**Newstan Colliery
Water Management Plan**

June 2021

DOCUMENT DETAILS	Name:	Newstan Colliery: Water Management Plan	
	Author:	Ian Gilmore and Stuart Gray (GHD Pty Ltd)	
	Revision No.:	1	
	Document Status	Final	
APPROVAL DETAILS	Revision No.	Trigger	Details of change
	0		Original water management plan
	1		Addressing comments from DPIE

Figure 1-2 Water management plans at Newstan Colliery

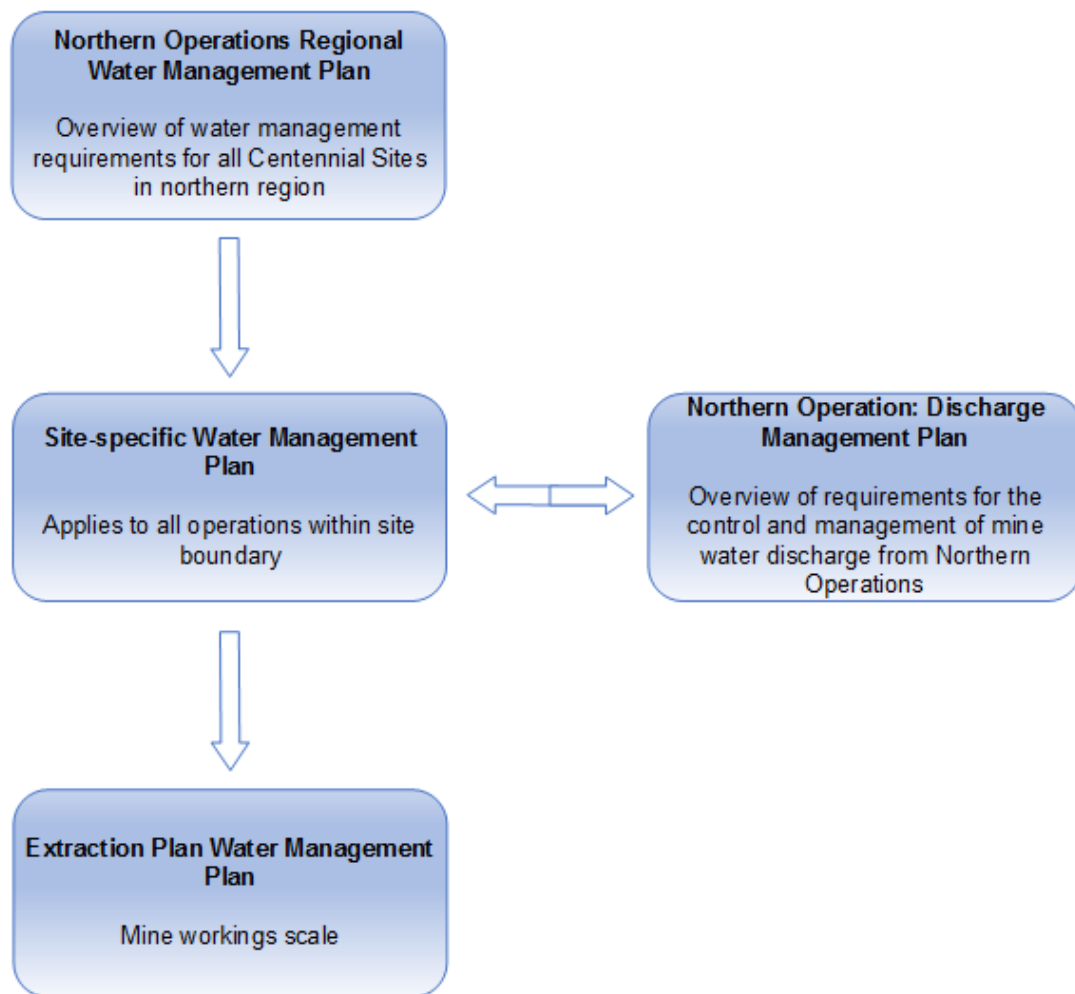
Comment	Response
Replace “Schedule” with “Condition” where occurring in Table 2-2.	Update complete
Figure 1-2 Newstan WMP is a part of the Northern Operations Regional Water Management Plan (NORWMP). The (Section 1.4.2) Northern Operations: Discharge Management Plan should also be included in the diagram.	Update complete
Section 1.2.2 Where is Section 0? Please identify correct reference.	Amendment complete
The information in T.4-3 and Fig.4-2 do not completely correlate. • Missing from Table 4-3 are bores: MB01, MB02B, AWG01, AWG02 • Missing from Figure 4-2 are bores: MB09, MB14, MB16, MB17 • Figure 4-3 does not display the following aquatic ecology monitoring sites: CCSC1, PCMH, SCCIZ	Table 4-3 updated to include AWG01 and AWG02. Other points were removed from Figure 4-2 as they are not currently part of the monitoring program or form the basis for management requirements. Figure 4-2 has been updated Figure 4-3 has been updated

Figure 2-2 Monthly rainfall and evaporation totals

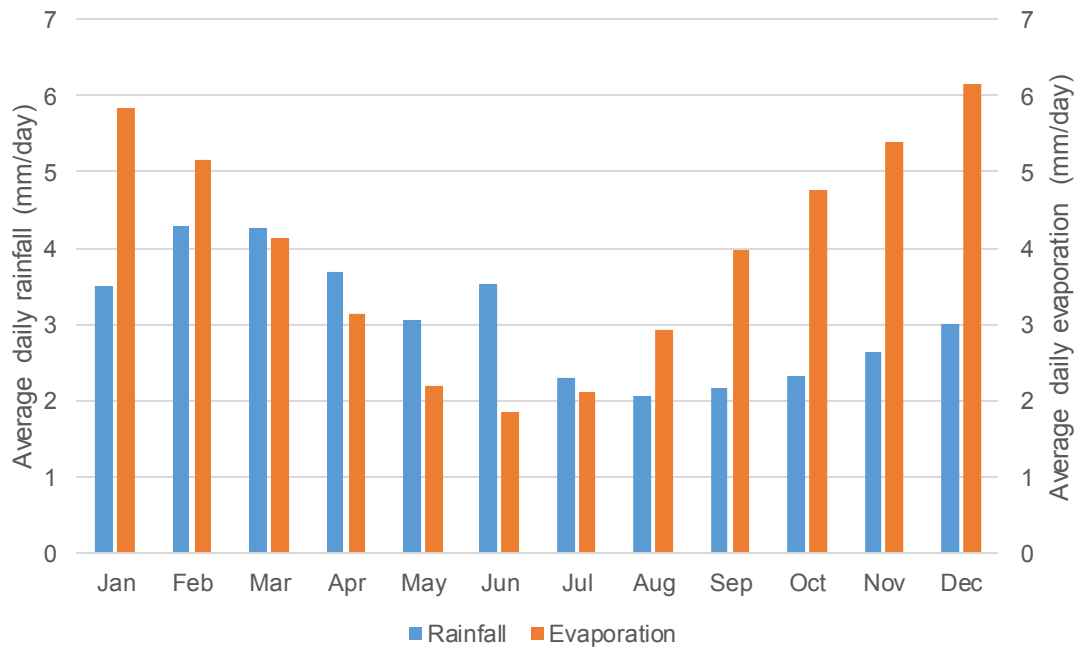
Other Comments on Water Management Plan
Update the cover from December 2019 to November 2020 Section 1.2.3 LDP001 add the word “to” after Clean Water Plant. Section 2 Remove the words “and evaporation” from paragraph 3 and the title to Fig. 2-1 Section 3.4 What is the meaning of the following sentence “<i>Dewatering underground from surface water storages occurs at a controlled rate, controlled through automated systems</i>”? Table 4.2 Nutrients- “NOx” is usually an air quality parameter. Compare this with Table 4-4 MB18 “<i>ammonia, nitrate, nitrite, nitrate + nitrite, total Kjeldahl nitrogen</i>”

<u>General comments</u>	
Update the cover from December 2019 to November 2020	Updated to issue date of May 2021
Section 1.2.3 LDP001 add the word “to” after Clean Water Plant.	Amendment complete
Section 2 Remove the words “and evaporation” from paragraph 3 and the title to Fig. 2-1	Amendment complete
Section 3.4 What is the meaning of the following sentence “ <i>Dewatering underground from surface water storages occurs at a controlled rate, controlled through automated systems</i> ”?	Sentence updated for clarity
Table 4.2 Nutrients- “NO _x ” is usually an air quality parameter. Compare this with Table 4-4 MB18 “ <i>ammonia, nitrate, nitrite, nitrate + nitrite, total Kjeldahl nitrogen</i> ”	Updated as suggested
Section 4.4: Underground water extraction and transfer states “daily monitoring ... is undertaken daily”.	Section reviewed and amended for clarity
Section 4.6 Please change second paragraph to read “ <i>Geomorphological stability is assessed in Stony Creek downstream of discharges from LDP017. This monitoring occurs following any discharge event, with 250 metres to be monitored downstream of the discharge point. Visual inspections are aided by indicators and photographs taken along the monitored length of the creek.</i> ”	Amendment complete

Figure 4-3

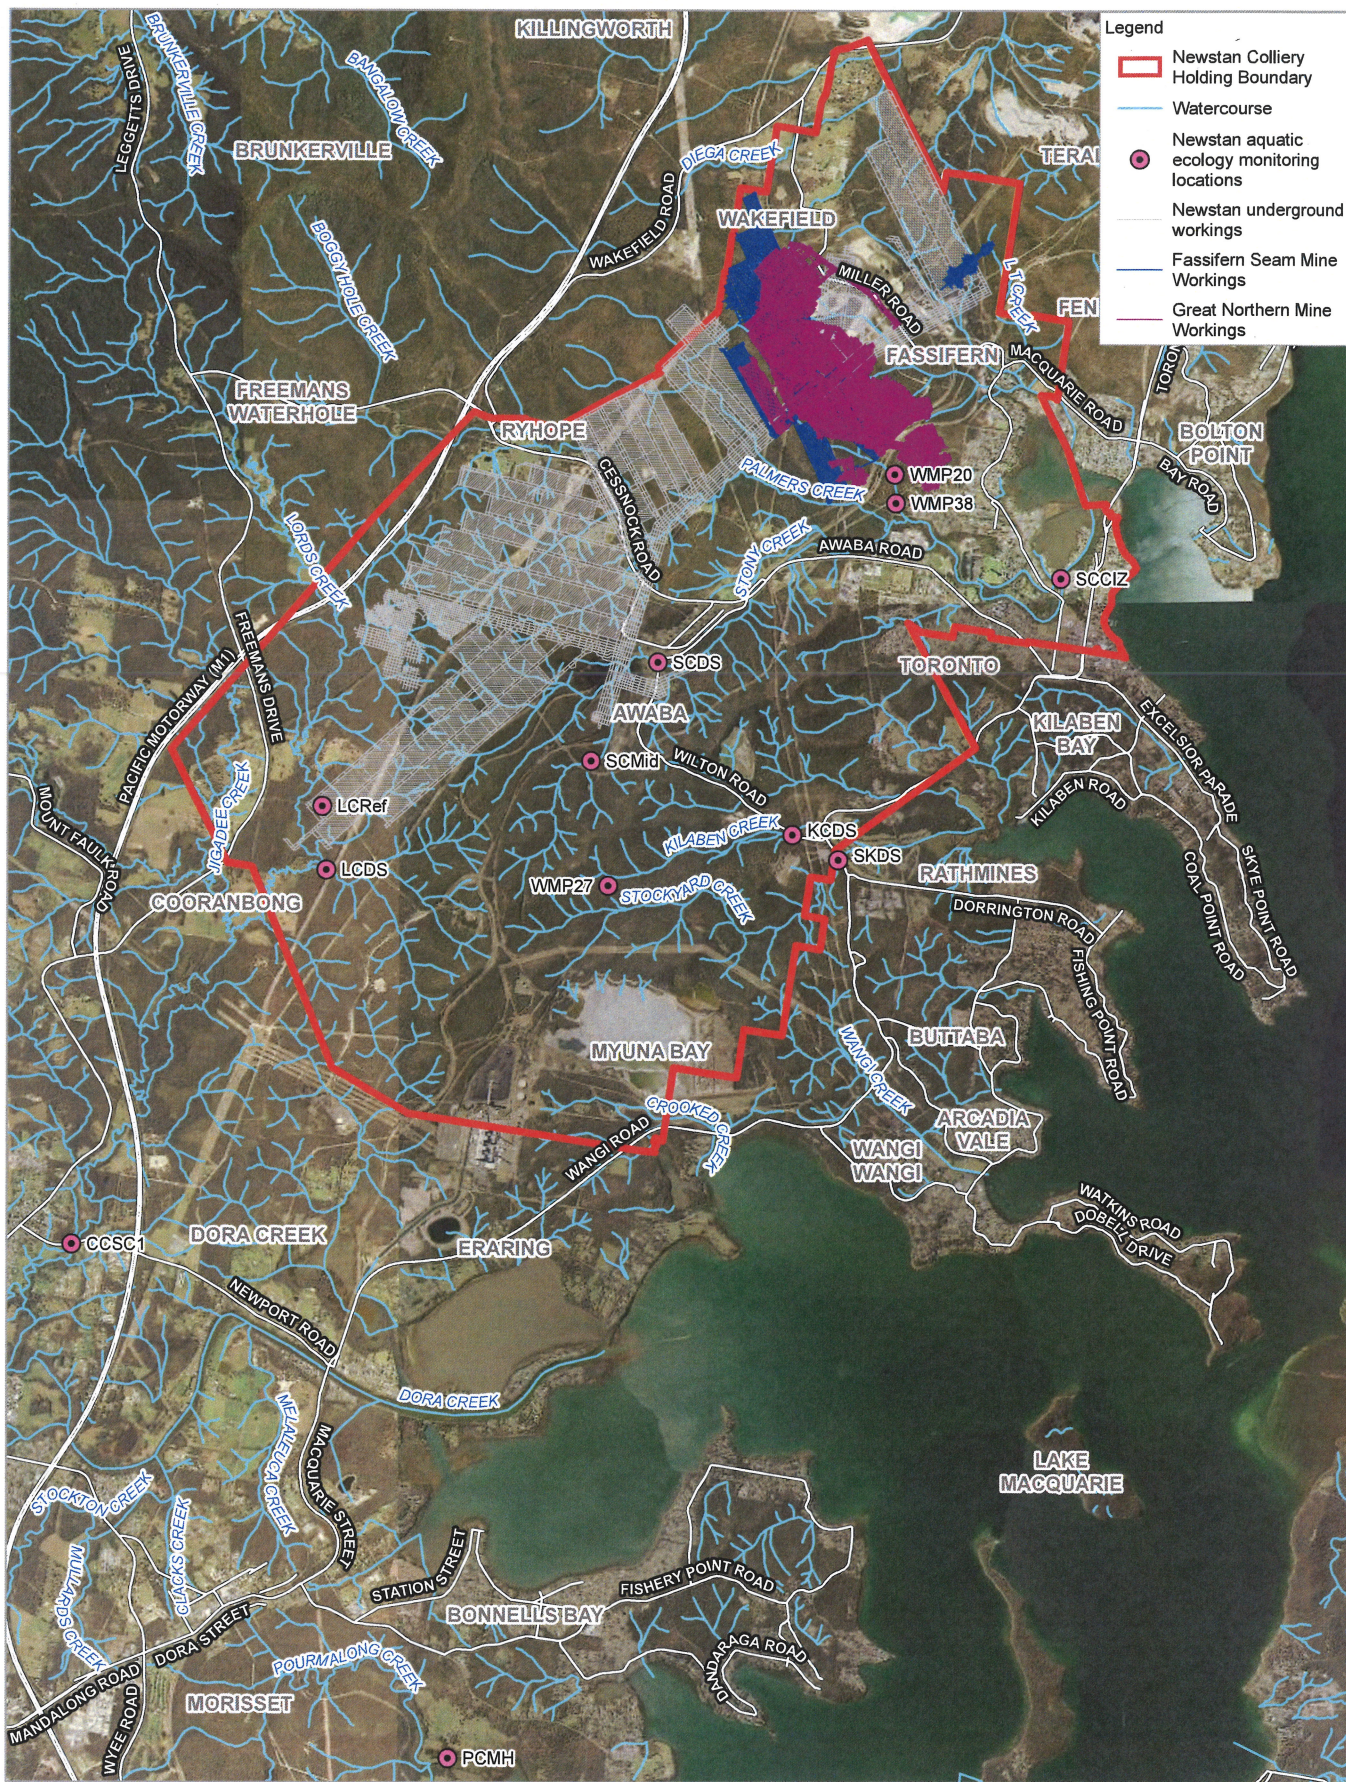
(i) management of the quality and quantity of surface and ground water within the areas covered by the water management plans, which shall include preparation of monitoring programs as provided by condition 8.2;	Partial	- The information in T.4-3 and Fig.4-2 do not completely correlate. - Missing from Table 4-3 are bores: MB01, MB02B AWG01 AWG02 - Missing from Figure 4-2 are bores: MB09, MB14 MB16 MB17 - Figure 4-3 does not display the following aquatic ecology monitoring sites: CCSC1, PCMH SCCIZ	Please correct Table 4.3 and Figure 4-2 so that they correlate. Please correct Table 4.5 and Figure 4-3 so that they correlate.	Section 4 addresses monitoring requirements and included inspections (S4.1), surface water monitoring (S4.2), groundwater (S4.3), underground extraction (S4.4), aquatic ecology (S4.5) - Bores AWG01 and AWG02 have been included in Table 4-3 and bores MB09, MB14 MB16 MB17 are included in Figure 4-3. Action: Bore AE6 is in the table, but does not appear to be on Figure 4-3. Update the table or the figure, whichever is correct. - The proponent stated that Table 4-3 was updated to include AWG01 and AWG02. Other points were removed from Figure 4-2 as they are not currently part of the monitoring program or form the basis for management requirements. - CCSC1, PCMH, SCCIZ sites are included in Table 4-5 and included on Figure 4-3	Partial Action: Bore AE6 is in the table, but does not appear to be on Figure 4-3. Update the table or the figure, whichever is correct.

Comment	Response
<u>General comments on Schedule 2: Condition 4.1</u>	
Bore AE6 is in the table, but does not appear to be on Figure 4-3. Update the table or the figure, whichever is correct	AE6 references have been deleted, it is no longer part of the monitoring program
Update Table 1-2 to include [Condition a) (xi)] relevant sections, including the Awaba Colliery Water Management Plan. Currently the table refers to the WMP	Addressed
With respect to monitoring and remediation strategies for streams adversely affected by subsidence...Include a statement <i>"Where the monitoring indicates any adverse impacts due to mining, the company shall implement the remediation strategy to the satisfaction of DPIEW"</i> is included in Section 4.	Addressed
Include a specific reference to the <i>NSW Wetland Policy</i> in Section 2.3 to ensure full compliance with this condition	Addressed, additional detail added around NSW Wetland Policy relevance.

Figure 5-1 Observed underground water transfers

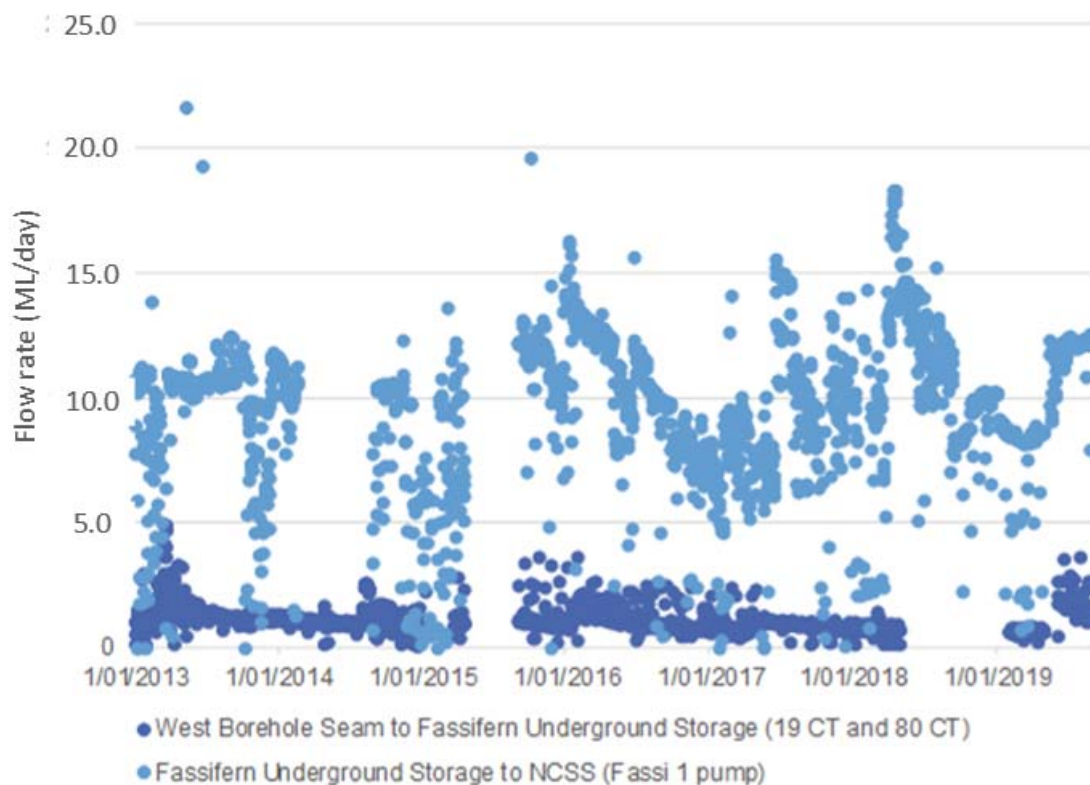
Figure 5-1 It would be helpful if the flow rate in the x-axis was in ML/day to match the units used in the text.

Figure 5-1 It would be helpful if the flow rate in the x-axis was in ML/day to match the units used in the text.				The x-axis legend has been updated to ML/day	Yes	
Section 6.1 Triggers Table 6-1 Please provide an explanation for the EC trigger value for WMP32. DPIE is unwilling to accept the high trigger value of 5690 $\mu\text{S}/\text{cm}$ without an acceptable explanation				A note has been added Table 6-1 which states <i>* Baseline monitoring indicates external influence on the waterways within this area and hence an elevated EC trigger value has been adopted. Existing land uses within the catchment include a landfill and electricity easements. There are no mining operations within the catchment.</i> See also the response to the DPIE question around the elevated EC levels discussed in Schedule 2: Condition 4.3 (b) which states that the proponent has reviewed the data after the 2020 monitoring.	Yes

Comment	Response
Figure 5-1 It would be helpful if the flow rate in the x-axis was in ML/day to match the units used in the text.	Amendment complete
Section 6.1 Triggers Table 6-1 Please provide an explanation for the EC trigger value for WMP32. DPIE is unwilling to accept the high trigger value of 5690 $\mu\text{S}/\text{cm}$ without an acceptable explanation	Amendment complete
Section 6.2.2 DPIE would prefer the following text to be moved to come after Table 6-8: <i>"Based on triggers derived in Section 6.1.4, Table 6-9 presents management criteria for the water level in the Fassifern underground storage"</i> .	Section updated to reference both Tables.
Section 7.1 NSW DoI W should be DPIE-Water.	Amendment complete
